Re: US DOE PORTS
General Correspondence
Remedial Response
Pike County
I.D.#466000865

RE: Technical Review of Structural Stability and Hydrological Interconnectedness of
Geological Units Associated with the Onsite Disposal Cell
Portsmouth Gaseous Diffusion Plant, Piketon, Ohio

**PORTSMOUTH GASEOUS DIFFUSION PLANT, PIKETON, OHIO
ON SITE DISPOSAL CELL GEOTECHNICAL FOUNDATION CAPACITY
REVIEW COMMENTS AND RECOMMENDATIONS**

Attachment 1 - Bearing Capacity Model

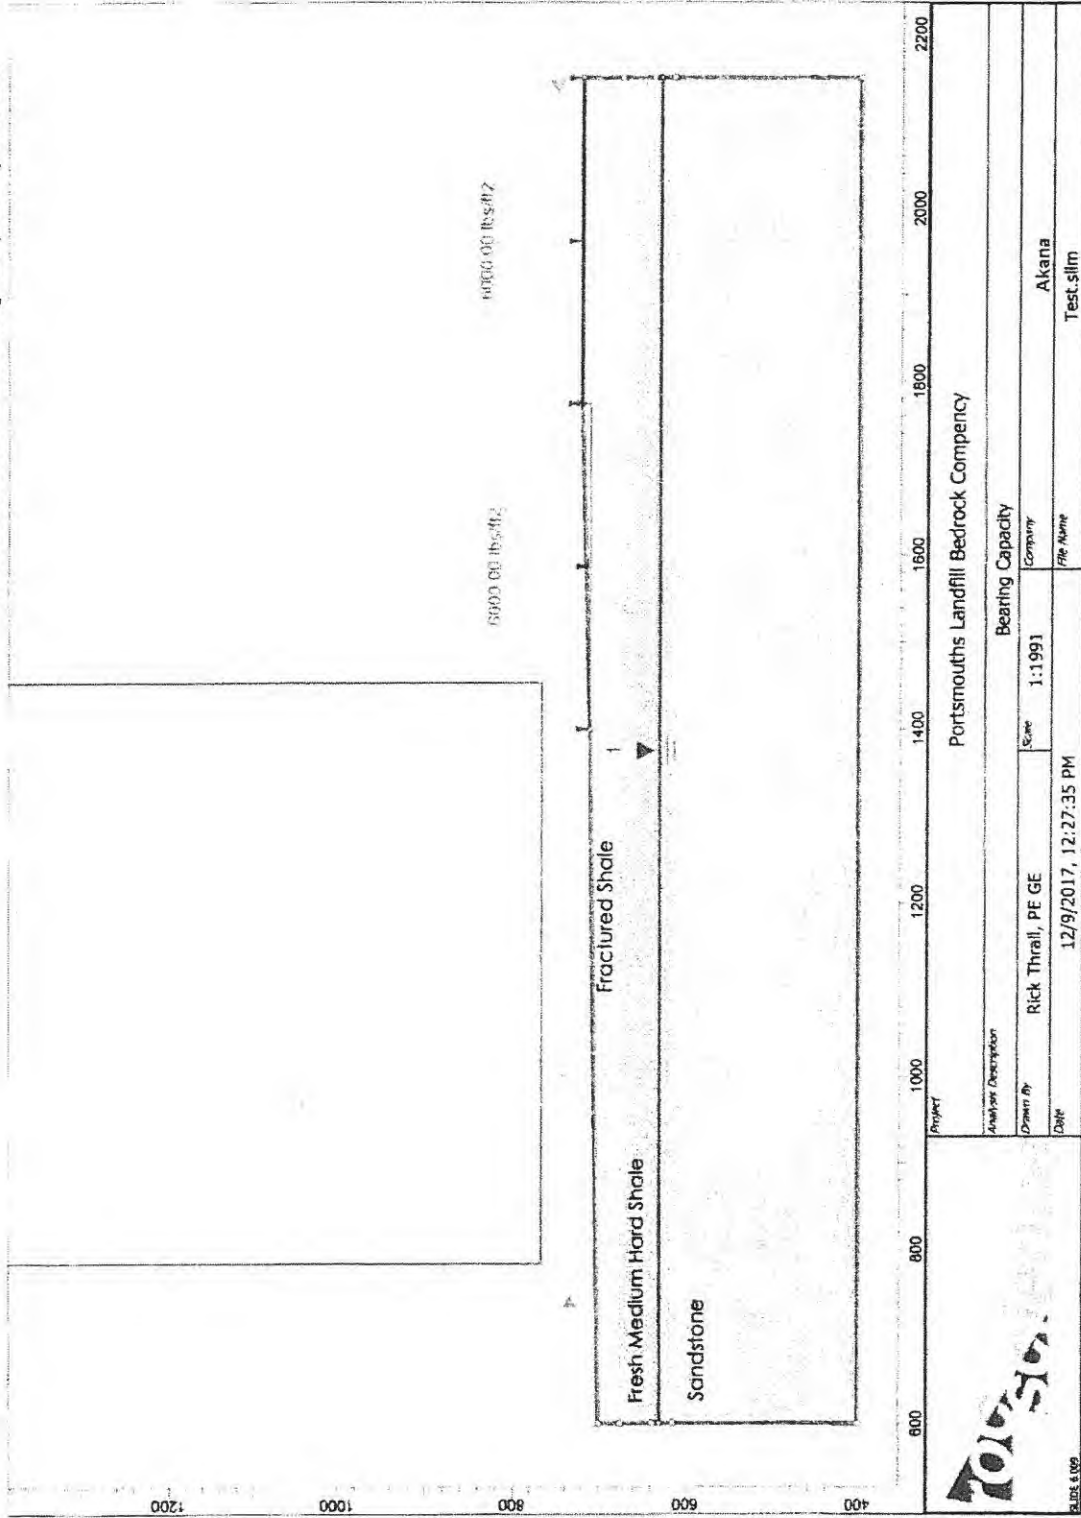
It is suggested that a graphic of slope stability failure lines/arcs from the analyses conducted be displayed overlain atop the geologic cross sections of concern. If a slope failure of either type (rotational, translational, veneer) is possible through the fractured rock underlying the location of the waste cells, further investigation may be necessary.

The loading was assumed to be distributed evenly across the footprint of the cell, resulting in static loads that would be concentrated in the center of the distribution. This is a reasonable assumption provided that best management practices are strictly adhered to during landfilling, however a more robust assessment might also include an uneven load distribution, or more eccentric loading across the cell or adjacent cells to model other landfilling scenarios. Another assessment may also include leachate collection above the primary liner in a worst-case-scenario evaluation that assumes any collection systems are not performing as designed or are underperforming.
